FINAL DECISION
Australian Gas Networks (SA)
Access Arrangement

2021 to 2026

Attachment 5
Capital expenditure

April 2021

Figure 5.2 Revised proposal and final decision 10 year capex

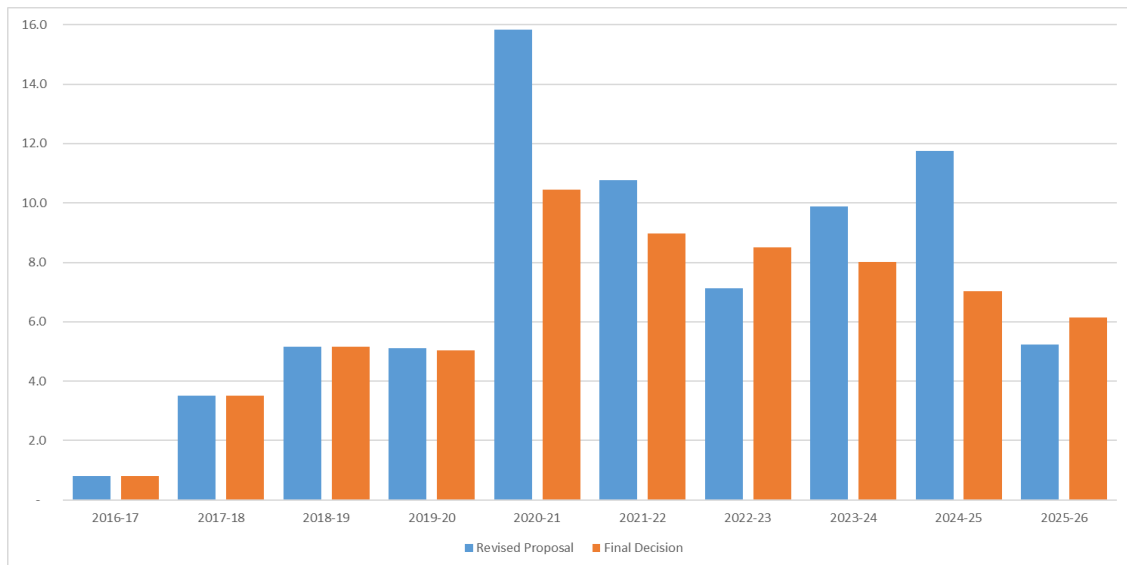
After our initial top down analysis, we worked with AGN to understand the changes in the revised proposal, and after participating in this process, AGN submitted an amended forecast for IT capex. Figure 5.2 provides an illustration by year of the amended forecast, while Table 5.7 shows the changes from AGN's revised proposal to our final decision.
